City of Columbia

Municipal Planning Commission

December 8, 2021

RE: Response to Technical Review Comments
Item No. 21-0205
1451 Lasea Road
Preliminary PUD Master Plan

LASEA TOWNHOMES
1451 LASEA ROAD
COLUMBIA, TENNESSEE

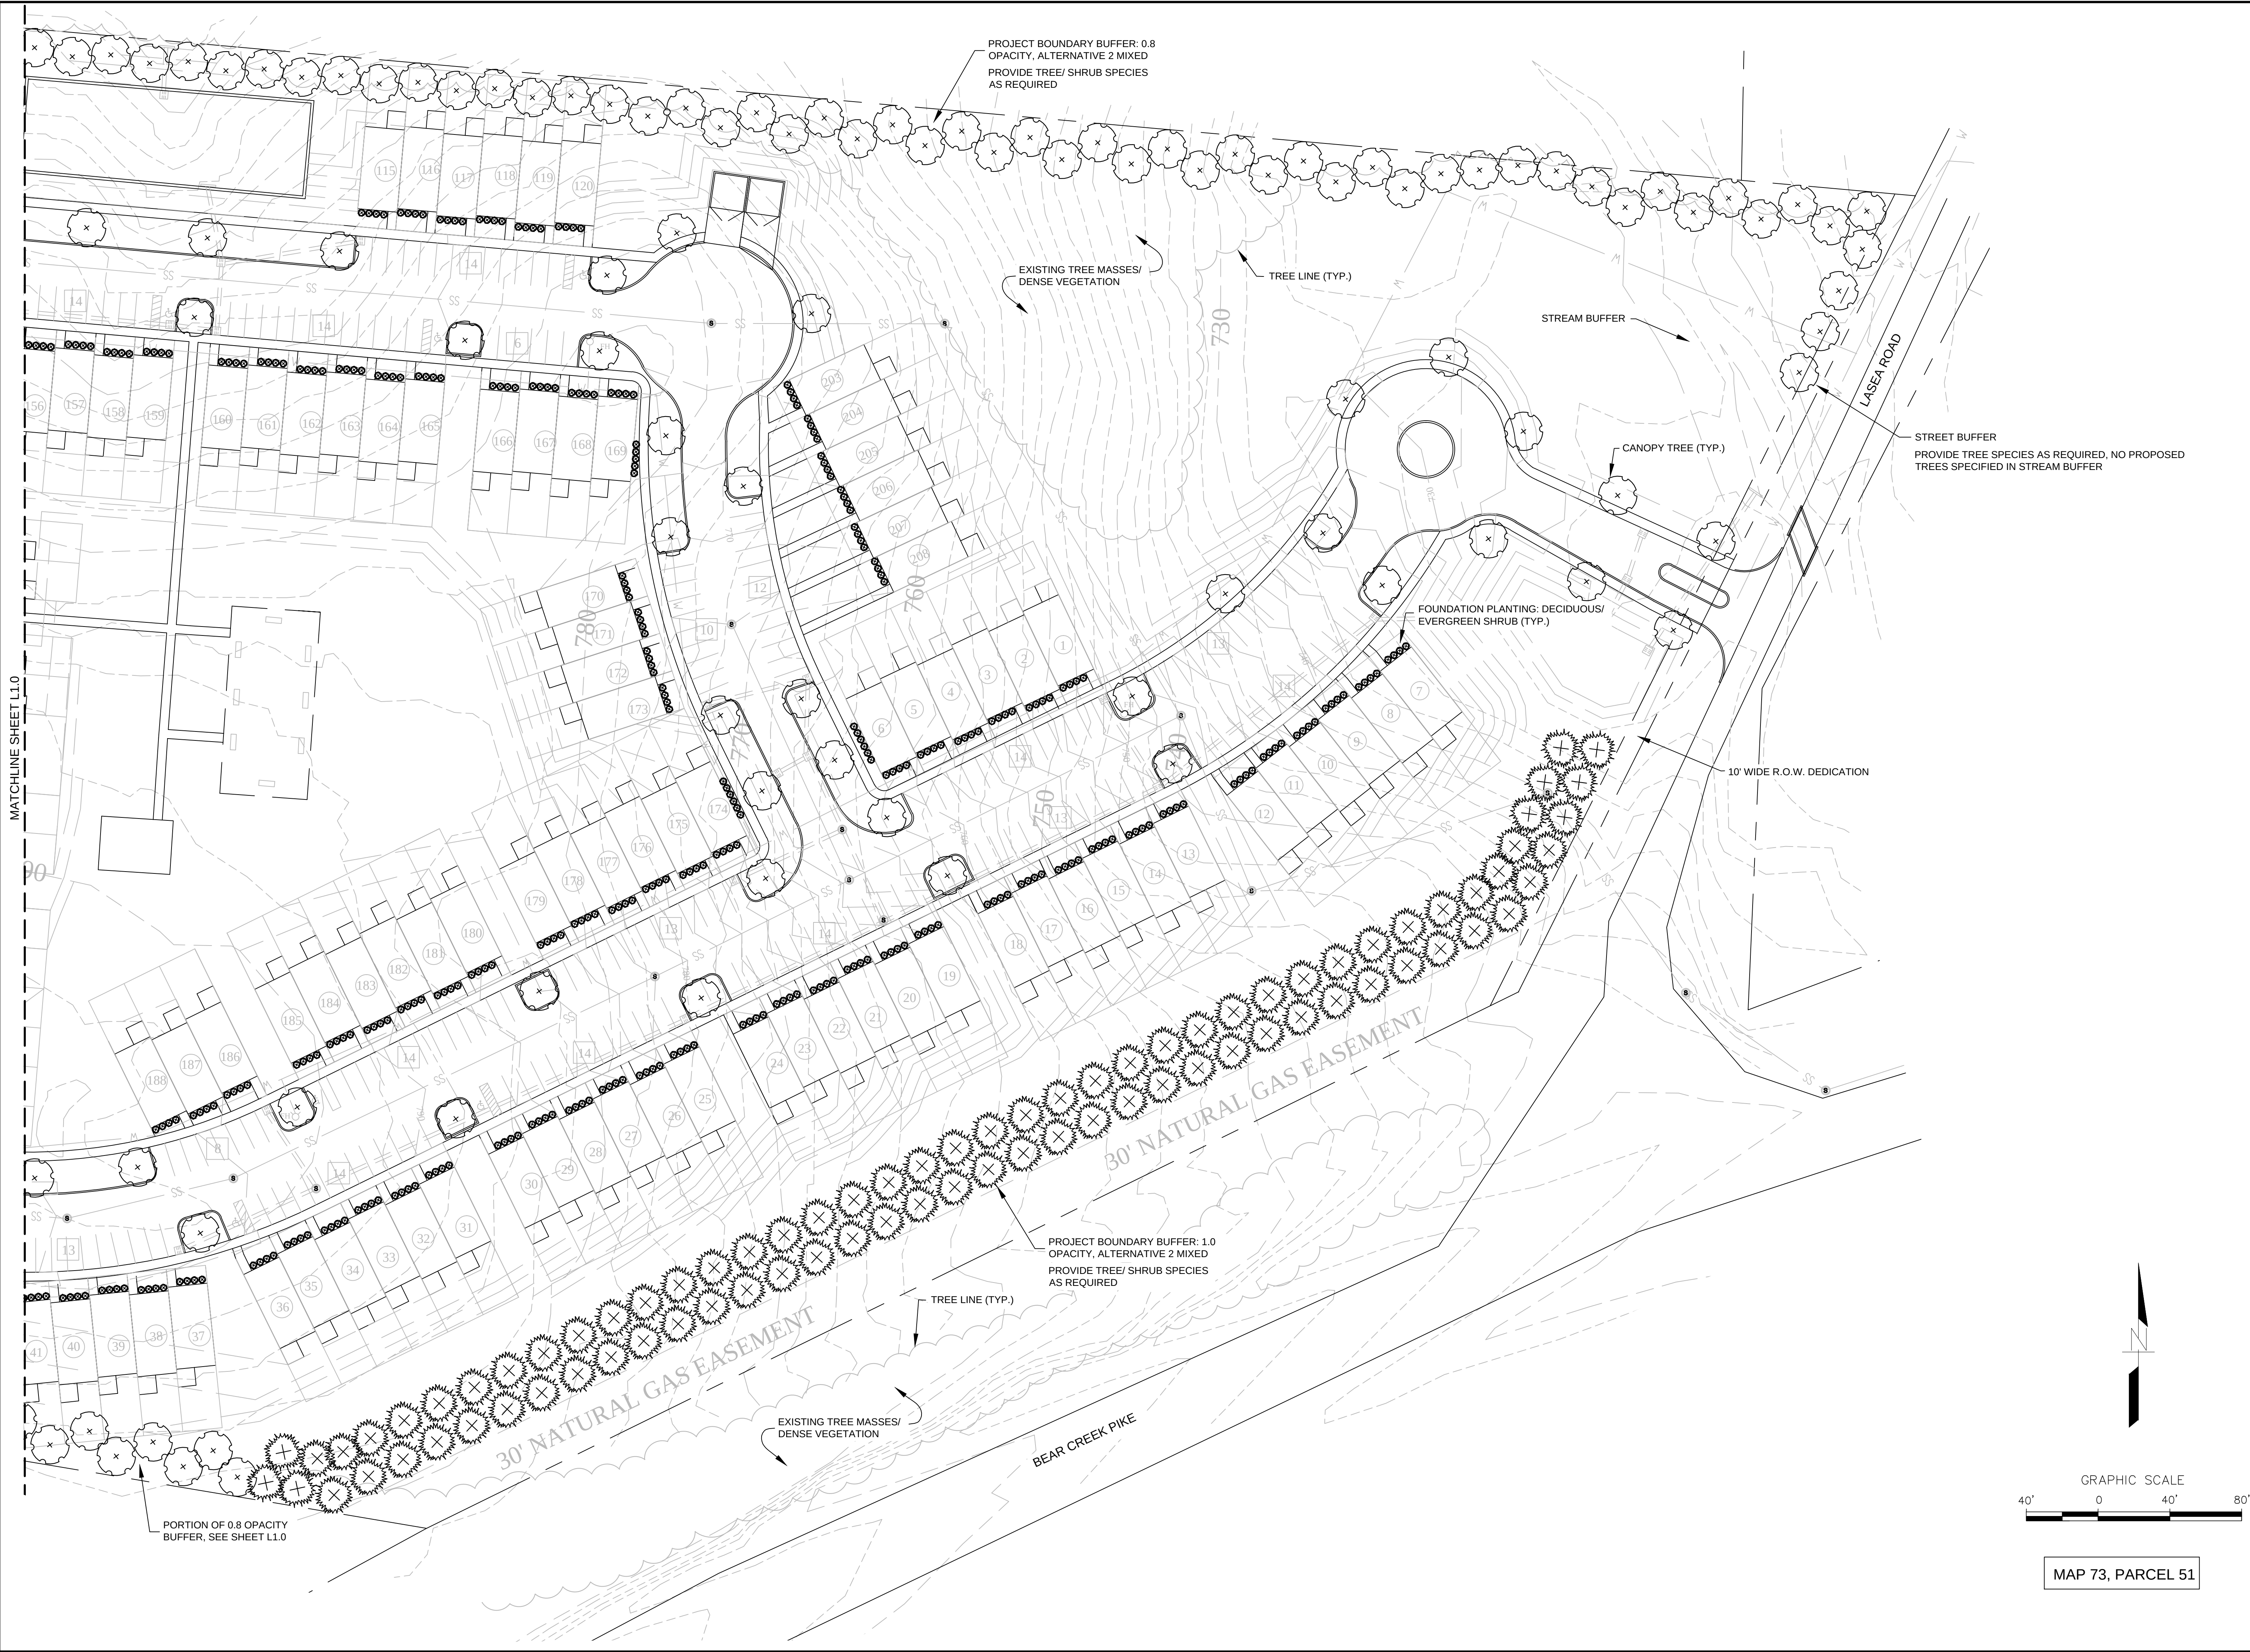
3. Private sanitation services are an option for townhomes, or our department can service them via dumpster service. For 208 townhomes, we recommend four (4) 8-yard dumpsters serviced 4 days a week. I only see 2 dumpsters enclosures/pads on the preliminary master development plan. Two dumpsters are not enough for 208 units. Please see attached dumpster guidelines and accessibility requirements. Note: The proposed dumpster location in the northeast cul-de-sac with the island will prove to be a clearance and accessibility issue for front load trucks attempting to service this dumpster enclosure. Please remove the island to remove clearance and accessibility issues. Thank you!

15. Stormwater detention areas appear small for the amount of impervious area.
16. Provide location and size of existing box culvert underneath Lasea Rd.

18. Provide hydrologic determination on pond.
19. ARAP permit will be required for creek crossing and culvert.
20. Show all aquatic resource buffers. Pumpkin Creek is evaluated as an Exceptional Resource. HUC #06040002

21. Show existing sinkhole/depression locations.

34. Lots 7-36 that have a rear facing facade facing Bear Creek should provide a detailed plan to screen or use a linear park area amenity.
35. Lots 37-44 shall face a drive or street

36. Building Elevations lack detail of all sides and materials, plans refer to a basement building elevation but not shown
37. Of the 208 units proposed 190 are of the same facade, would recommend providing some variation

39. Parking lot lighting areas with photometric required at construction plan stage.
40. Lots 79-96 are missing the sidewalk
41. This is abutting a very rural area on two sides and overall would recommend spacing and building types to blend into the adjacent properties.

3. Private sanitation services are an option for townhomes, or our department can service them via dumpster service. For 208 townhomes, we recommend four (4) 8-yard dumpsters serviced 4 days a week. I only see 2 dumpsters enclosures/pads on the preliminary master development plan. Two dumpsters are not enough for 208 units. Please see attached dumpster guidelines and accessibility requirements. Note: The proposed dumpster location in the northeast cul-de-sac with the island will prove to be a clearance and accessibility issue for front load trucks attempting to service this dumpster enclosure. Please remove the island to remove clearance and accessibility issues. Thank you!

Note: we have added six additional dumpsters with concrete pads and enclosures

15. Stormwater detention areas appear small for the amount of impervious area. Note we have enlarged them.
16. Provide location and size of existing box culvert underneath Lasea Rd. Provided

18. Provide hydrologic determination on pond. Will be provided during construction drawing phase
19. ARAP permit will be required for creek crossing and culvert. We have moved the entrance to protect the stream and provide buffers

20. Show all aquatic resource buffers. Pumpkin Creek is evaluated as an Exceptional Resource. HUC #06040002 We have provided a stream buffer and moved the entrance to protect the stream

21. Show existing sinkhole/depression locations. Possible sinkholes shown
22. Maximum grade for drives is 10%. Grades over 10% have been eliminate
23. Maximum grade for parking stalls is 8% Maximum grades in parking areas is no less than or equal to 8%

26. Intersections shall skew no more than 20 degrees from 90 degrees. Intersections have been revised
27. City requests a dedication of ROW along the property frontage on Lasea Rd. A minimum of 35' from the centerline of the road. 10' dedication provided

33. Landscape buffers are missing on several property lines, overall the buffer area should be reviewed for compliance and additional spacing for areas to help blend high density to rural. Buffers provided
34. Lots 7-36 that have a rear facing facade facing Bear Creek should provide a detailed plan to screen or use a linear park area amenity. Screen provided
35. Lots 37-44 shall face a drive or street Revised

- 36. Building Elevations lack detail of all sides and materials, plans refer to a basement building elevation but not shown Provided
- 37. Of the 208 units proposed 190 are of the same facade, would recommend providing some variation Provided
- 38. Show details of the amenities, address playground with no access, and overall area looks small for number of units and location to public facilities. Details provided
- 39. Parking lot lighting areas with photometric required at construction plan stage. Acknowledged
- 40. lots 79-96 are missing the sidewalk Added
- 41. This is abutting a very rural area on two sides and overall would recommend spacing and building types to blend into the adjacent properties. Buffers provided
